Product Change Notification

Change Notification #: 116580 - 00
Change Title: Intel® RAID Module RMSP3AD160F
Intel® RAID Module RMSP3CD080F
Intel® RAID Module RMSP3HD080E,
PCN 116580-00, Product Design, Label,
Add KCC Logo and Firmware Update
Date of Publication: November 05, 2018

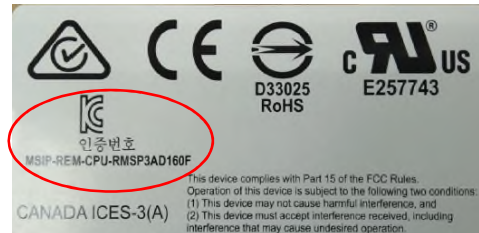
1. Update the firmware version to 5.020.00-0838 (MR 7.2p1 on firmware package 50.2.1-0589)
2. Add the KCC logo for Korea certification

Before

After
